Following are comments from the TPO Staff regarding the preliminary plans that were presented at the June 30, 2015 Public Meeting for the proposed improvements to Washington Pike between I-640 and Murphy Road:

WASHINGTON PIKE ROADWAY IMPROVEMENTS PROJECT
PUBLIC MEETING
June 30, 2015

Figure 33 – Proposed National Register Boundary in blue for Murphy Springs Farm (KN-2586) with neighboring parcels shown in pink.

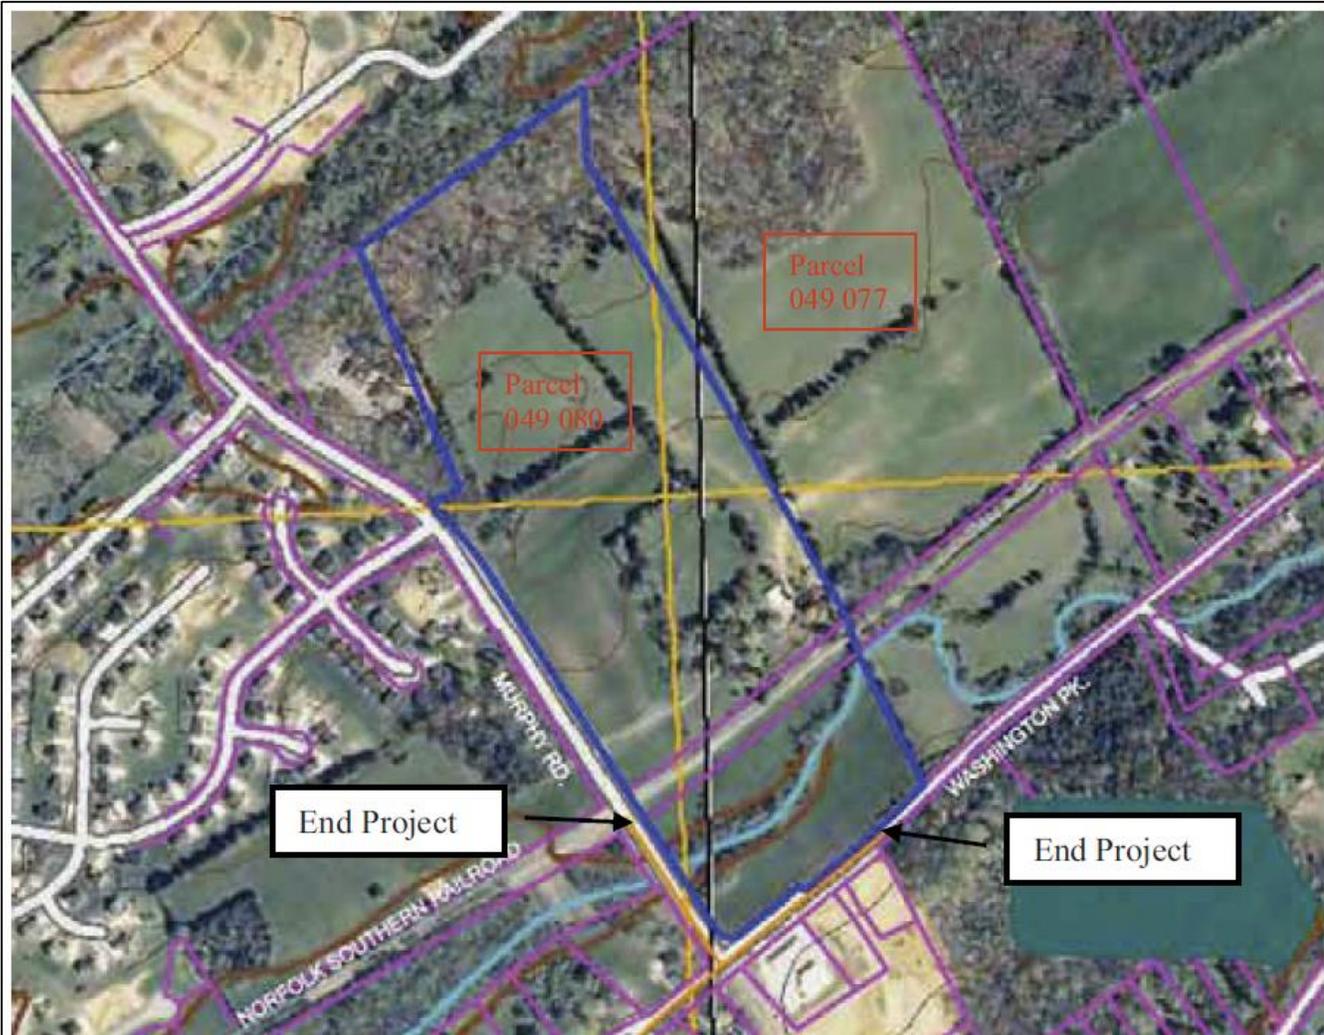
The boundary for Murphy Springs Farm is different than the boundary used to assess impacts. The Effect Determination from the Tennessee State Historic Preservation Officer dated March 12, 2013 was not based on the correct boundary, and therefore, the assessment of impacts and effects needs to be reviewed and revised. The correct district boundary includes a portion of Murphy Road south of the railroad tracks, which is part of the project scope analyzed in the report.

Secondly, the drawing on page 37 of the report does not represent the correct southern boundary of parcel 049 080. Parcel 049 080 extends to the centerline of Washington Pike from its eastern end until the point where the right-of-way expands, just west of the driveway to the pharmacy and restaurant. The figure on page 37 depicts some work, including widening and fill, inside of the district boundary on the eastern end of Washington Pike.

Figure 5 – Roundabout with Right-Turn Bypass Lane at Murphy Road

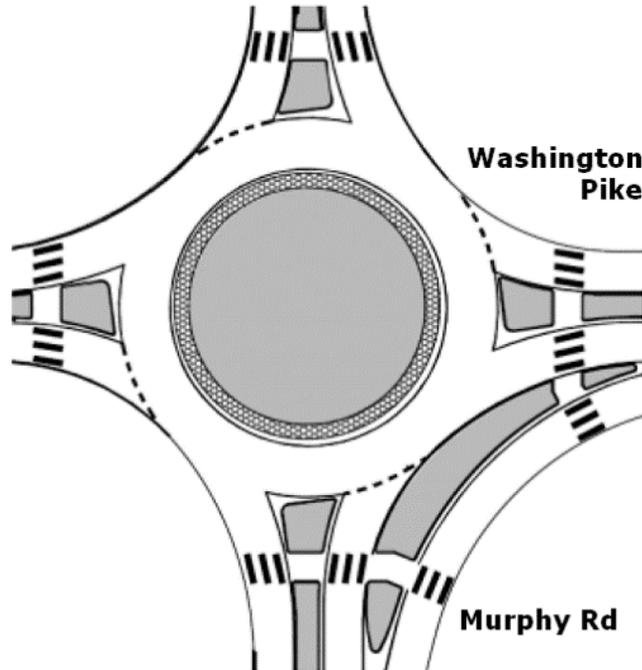
Modified roundabout designs may be needed to accommodate the unique traffic patterns of the project area. Example: The traffic numbers for the Murphy Rd / Washington Pike intersection may indicate a multi-lane roundabout is needed, or that it may not even be sufficient. However, I'd bet that a single-lane roundabout will work well at that intersection, if a dedicated right-turn bypass lane from Murphy Rd to Washington Pike is added, and then tapers into the Washington Pike traffic heading into Knoxville. Right-turn bypass lane capacity forming a new lane adjacent to existing traffic (non-yielding bypass lane) had not been modeled by FHWA in the 2010 report (*Roundabouts*, page 4-13), but "its capacity is expected to be relatively high due to a merging operation between two traffic streams at similar speeds."

Same situation at Mill Rd / Washington Pike for traffic turning right from Mill Rd to Washington Pike - single lane roundabout, dedicated right-turn from Mill Rd to Washington Pike.

Figure 6 – Different Project Areas – Planning Phase and Design Phase

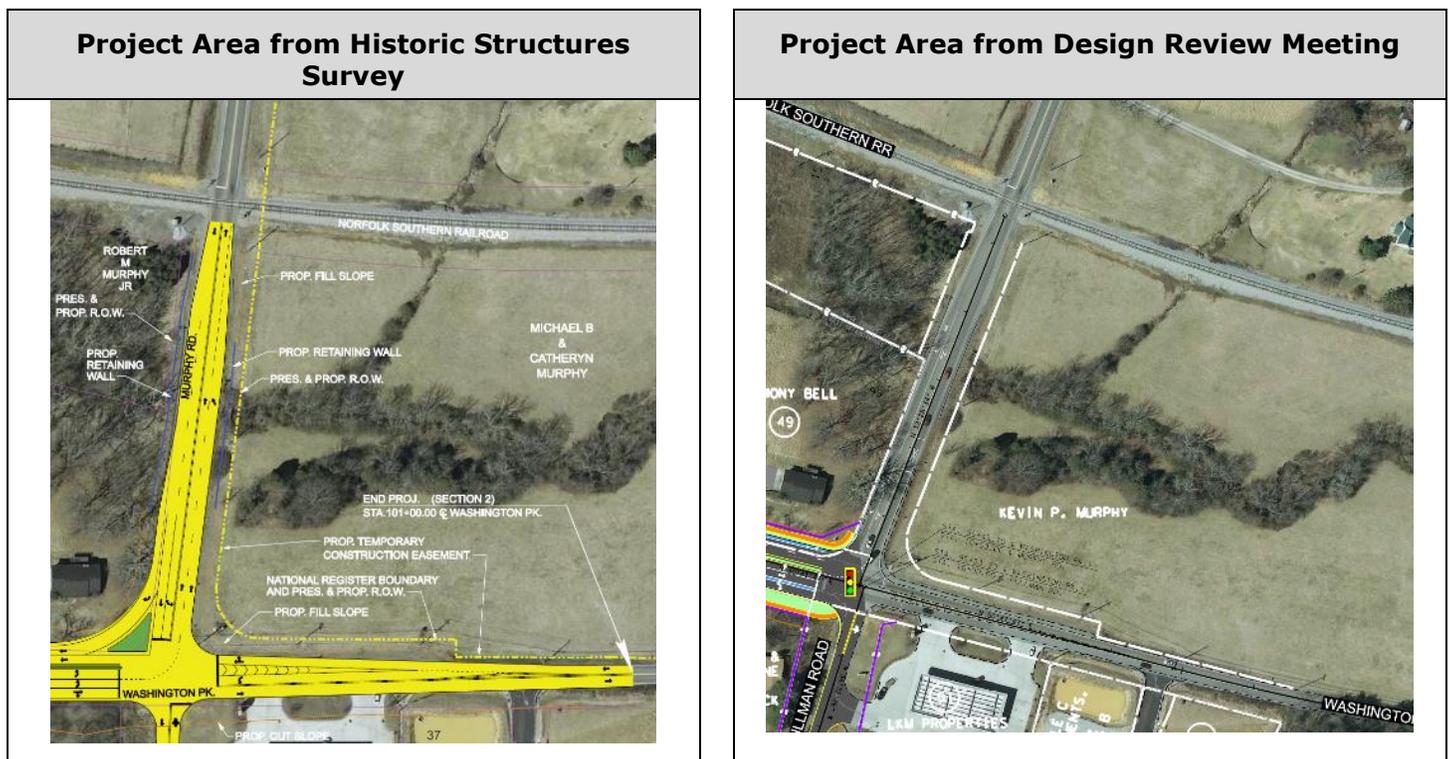
I am extremely concerned that the Project Scope during the Planning Phase is different than the scope of the project presented at the Design Review Meeting on June 30, 2015. The design review meeting showed the project stopping at the intersection of Washington Pike and Murphy Road. The functional plans, and all of the related assessments in the Planning Phase, had analysis based on the project continuing north of that intersection along Murphy Road to the railroad tracks, and east of the intersection along Washington Pike.

The functional plan from the planning phase, and the preliminary design have different designs at the Murphy Rd / Washington Pike intersection. The Preliminary Design presented June 30th does not have two right turn lanes from southbound Murphy Road to Washington Pike. The addition of these turn lanes was identified as a mitigating measure that would eliminate queuing in front of Murphy Springs Farm in the Historic Structures Report (p.36); this design does not include that mitigating measure.

Figure 10 – Cross Section that applies to approximately 55% of project length. No median.

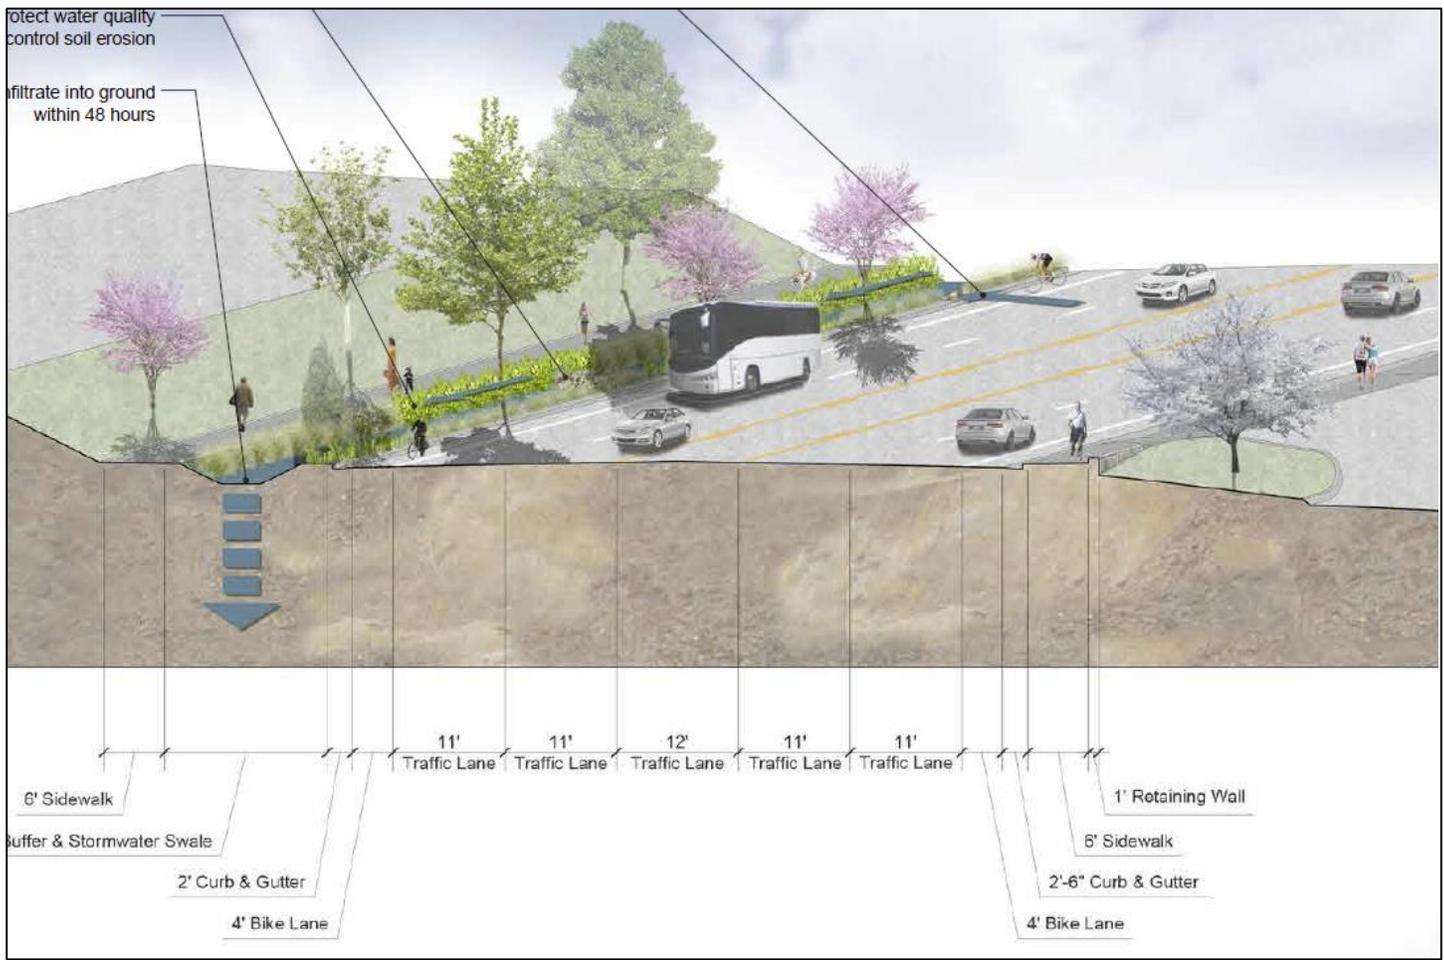
My rough measurements show that there is no median for approximately 55% of the project length; just a center turn lane. The remaining 45% of the project length has a much narrower median; of that, less than 1,000ft is a planted center median while the rest is a 2-4ft concrete median. That isn't what was proposed during the planning phase. The neighborhood was told one thing; something else is on the design document.

The planted medians should be continued through the entire length of the project. I noticed that no property was planned to be acquired from Target for additional right-of-way. Why is that? It's just parking lot up there; property should be acquired from that parcel in order to provide the width required for the Typical Section design shown at the meeting.
